| | T0900014-v1 | |
| UK UIM Coil Driver Pre-Production Prototype Bench Test and Evaluation | | |

This report documents the bench test results and evaluation of the AdL Suspension UIM Driver Pre-production Prototype chassis supplied by the University of Birmingham. Bench tests were conducted in accordance with LIGO document number T080021-v2, "UK UIM Driver Pre-Production Test Plan". A link to the completed test plan with results is included in Appendix A of this document. The design requirements for the UIM Driver can be found in LIGO document number T060067-00-C, "AdL Quad Suspension UK Coil Driver Design Requirements".

Figure 3: UIM PP Chassis Serial Number

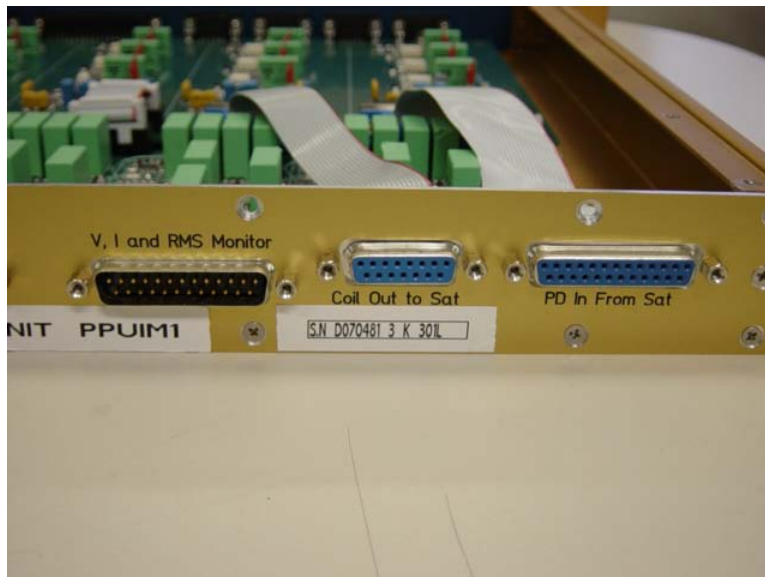
As can be seen from the photos, front and rear panel panels are professionally manufactured and all connection clearly labeled. The serial number for the chassis appears on the back panel and is applied using a label maker. This should be acceptable for production units.

Figure 6: UIM PP Monitor Board Jumper Wires

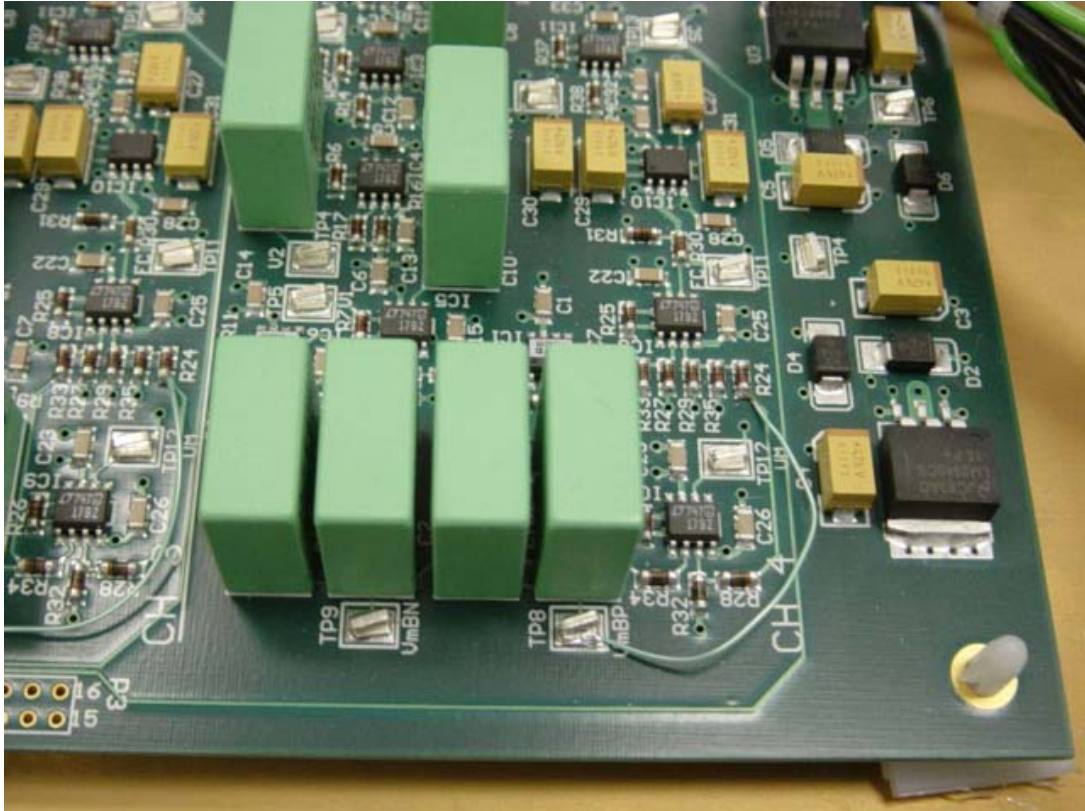
- The jumper wires on the monitor board used to correct a layout problem (see figure 6 below) represent a possible failure mechanism. If the layout of the monitor board is not corrected prior to production, a more robust means of attaching and securing the jumper wires needs to be devised.

The Monitor board was manufactured in a similar fashion and the only circuit board issues observed are the wires added from TP8 to R24 of each channel. These wires were added after circuit board

manufacture to correct an omission. It should be noted that one of these wires was broken free on the R24 end of the connection during shipment from the UK to the US. Prior to testing this connection was repaired. Production models of the Monitor board should be corrected so that these wires are not necessary. Both boards (driver and monitor) are identified in the space provided with the drawing number, revision number and serial number for the board. The circuit board (pcb artwork) revision number is included on the silkscreen for each board.

Figure 8: Noise Monitor Transfer Function, Measured from Driver Input to Monitor Output

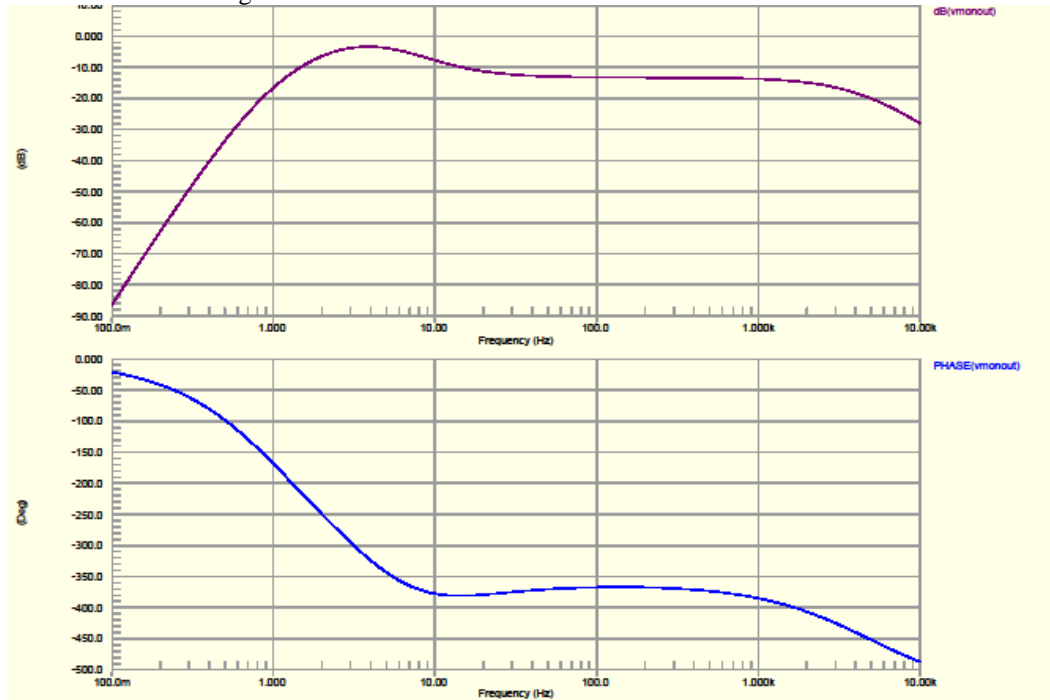
The measured transfer functions for all four channels were found to be in close agreement with the Altium simulation, but as was previously stated in section 4.1.2 of this report, the noise monitor circuit needs to be redesigned to measure the full output noise of the driver at 10Hz. Once the circuit has been redesigned, the transfer function tests will need to be repeated.
